## Morecambe Offshore Windfarm: Generation Assets Development Consent Order Documents

### Draft Marine Mammal Mitigation Protocol (Tracked)

PINS Document Reference: 6.5.1

Rev 024

Plate 3.1 Flowchart diagram showing the mitigation process prior to piling *(based on current Project design)*

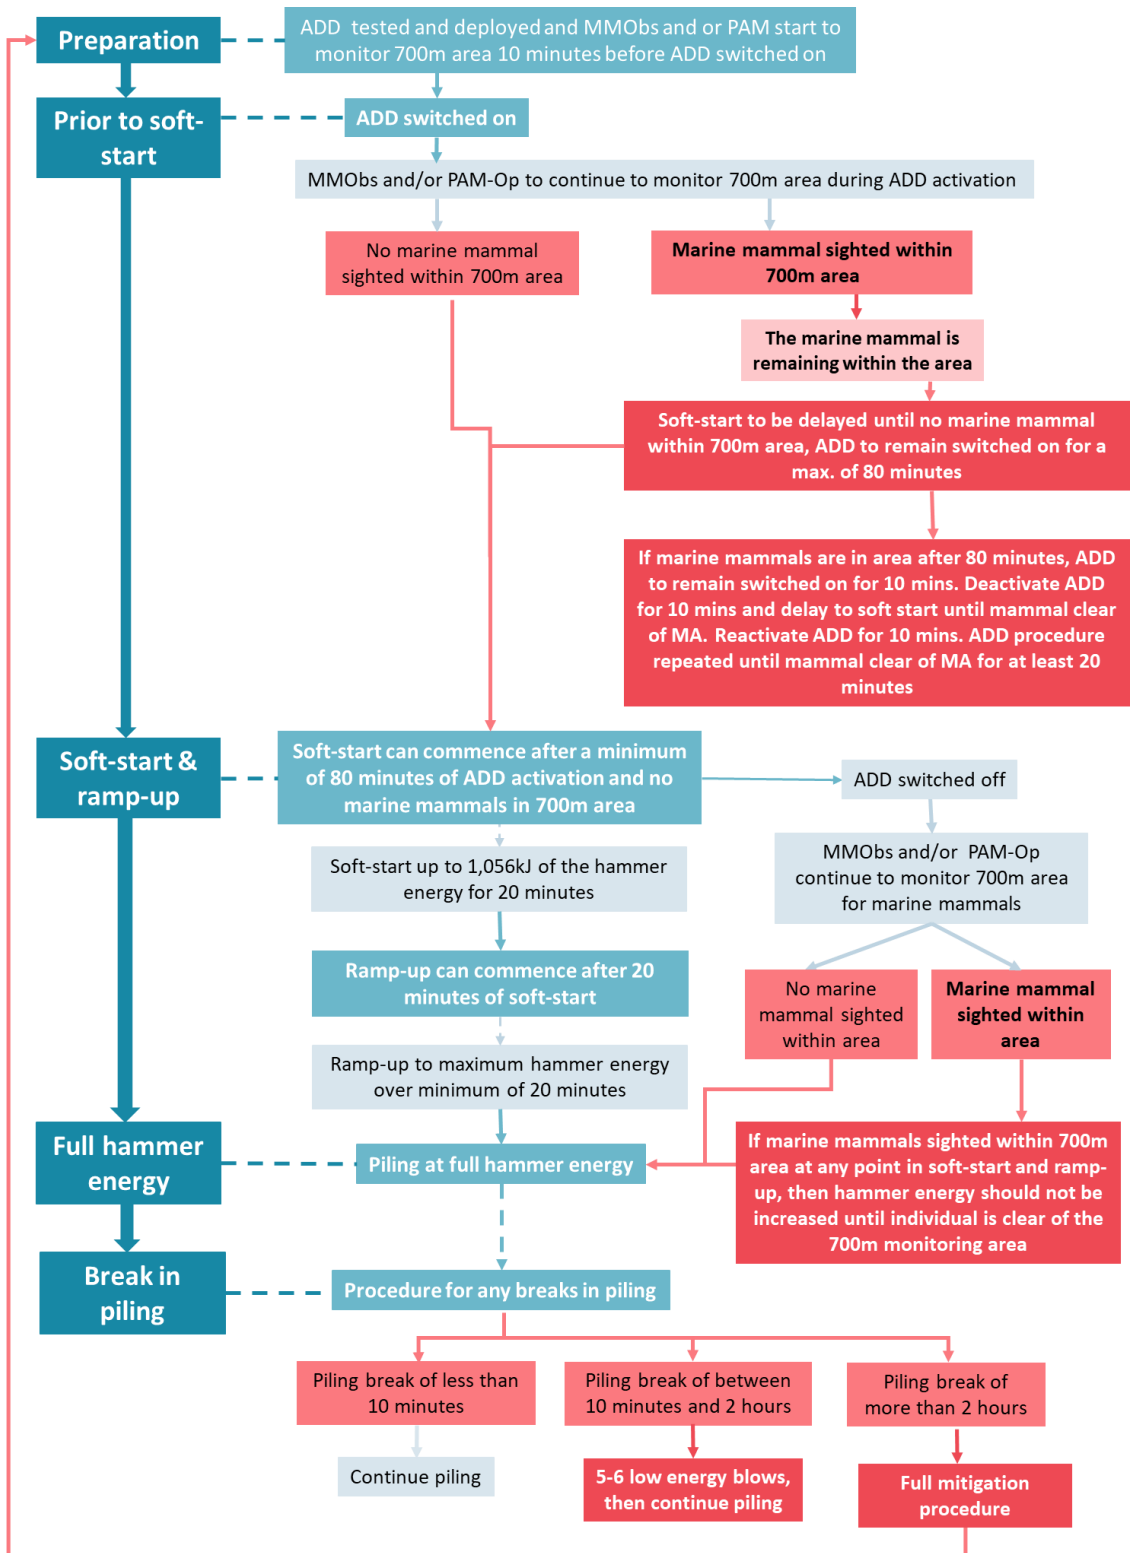
- Establishment of a MA with a minimum ~~700m~~ 500m radius (see **Section 3.1.1**). The observation of the MA would be conducted by trained, dedicated and experienced MMObs during daylight hours and when conditions allow suitable visibility (visibility of entire MA; sea state 3 or less)
  - Deployment of PAM devices in the MA during poor visibility or at night
- The activation of ADD (see **Section 3.1.2**)
- Soft-start and ramp-up (see **Section 3.1.3**)
- Procedure for breaks in piling (see **Section 3.1.4**)

~~100.~~99. The process through which the mitigation takes place is demonstrated in a flow-chart in **Plate 3.1**.
